Advisory – PCN UPDATE

Product Group: Vishay Siliconix/ March 20, 2019

SUBJECT: POD update related to PCN SIL-0092017

Additional Commercial Power MOSFET Manufacturing Capacity Expansion

POD from GEM Electronics:

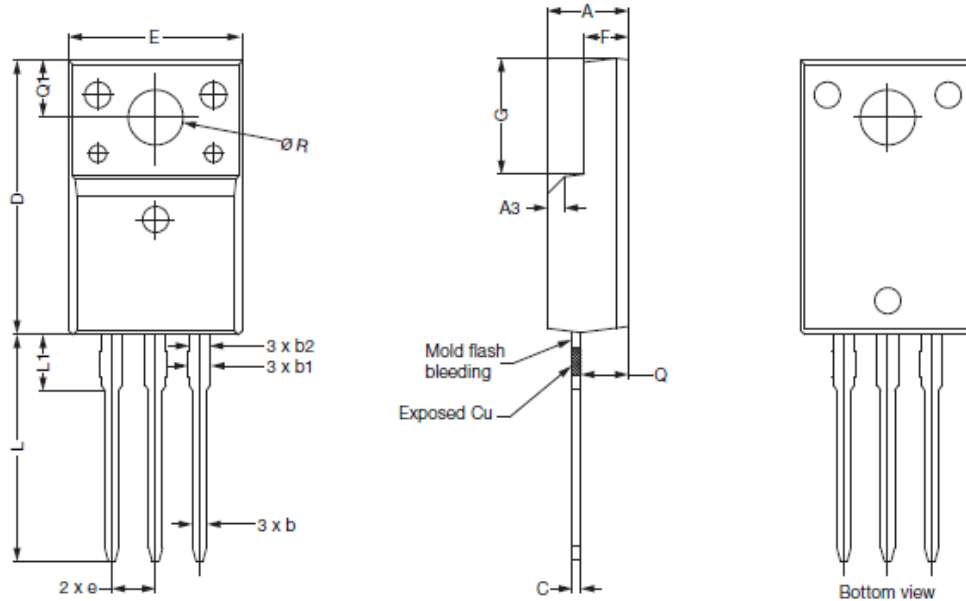
This advisory is being provided to you as an announcement that when the subject PCN was issued on July 18, 2017 for additional commercial Power Mosfet manufacturing capacity at GEM Electronics for Vishay's TO-220 Full-Pack package, the document did not articulate some of the differences for the dimensions as the GEM version of the package is slightly different.

The updated POD drawing is below for your reference. We have already started the process to update the POD/package dimensions on all our documentation including the Vishay website.

As the subject PCN already expired, you might be getting products based on either options. We believe the differences are small enough not to expose any quality or reliability risk to your production.
